Access Compliance Report

Public Rights-of-Way

(Curb Ramps)

Intersection ID: 6720	Main Street: DEBERRY_CT	Cross Street: ROUNDEAF_DR	Location:	E
ADA ID: 73BFAE7FAD00	Ramp Type: Perp	Initial Pass/Fail: Fail	Overall Compliance: No	Severity Score: 22.5
Codes/Mitigation Info/Possible Solution		Field Measurements/Component Compliance

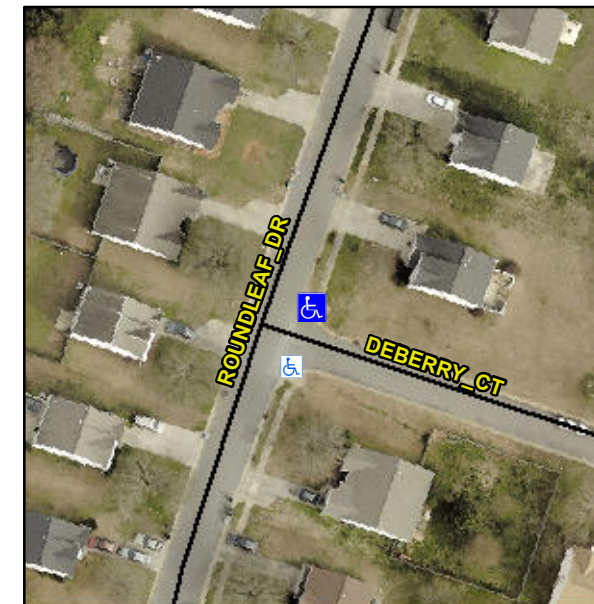
Not Found, R304.5.1, R304.2.2, R304.5.3

Compliance	Description	Data	Compliance	Description	Data
N/A	Ramp Length (in)	47.0	No	Ramp Slope (%)	8.4
No	Ramp Width (in)	41.0	No	Ramp XSlope (%)	2.3
N/A	Flare Type LT	N/A	N/A	Flare Type RT	N/A
N/A	Flare Slope LT (%)	N/A	N/A	Flare Slope RT (%)	N/A
N/A	Flare Traversable LT?	N/A	N/A	Flare Traversable RT?	N/A
N/A	Landing Length (in)	N/A	N/A	DWS Provided?	N/A
N/A	Landing Width (in)	N/A	N/A	DWS Contrast?	N/A
N/A	Landing Slope (%)	N/A	N/A	DWS Length (in)	N/A
N/A	Landing X Slope (%)	N/A	N/A	DWS Full Width?	N/A
N/A	Landing Curb? (Y/N)	N/A	N/A	DWS Offset (in)	N/A
N/A	Shared Landing?	N/A			
N/A	Gutter Ponding?	N/A	N/A	Gutter Slope (%)	N/A
N/A	Gutter Lip Ht (in)	N/A	N/A	Gutter X Slope (%)	N/A
N/A	Painted X Walk1?	No	N/A	Painted X Walk2?	N/A
	X Walk 1 Direction	To E		X Walk 2 Direction	N/A
N/A	X Walk 1 Width (in)	N/A	N/A	X Walk 2 Width (in)	N/A
	X Walk 1 Slope (%)	0.1		X Walk 2 Slope (%)	N/A
	X Walk 1 X Slope (%)	2.3		X Walk 2 X Slope (%)	N/A

Remove & Replace Entire Ramp.
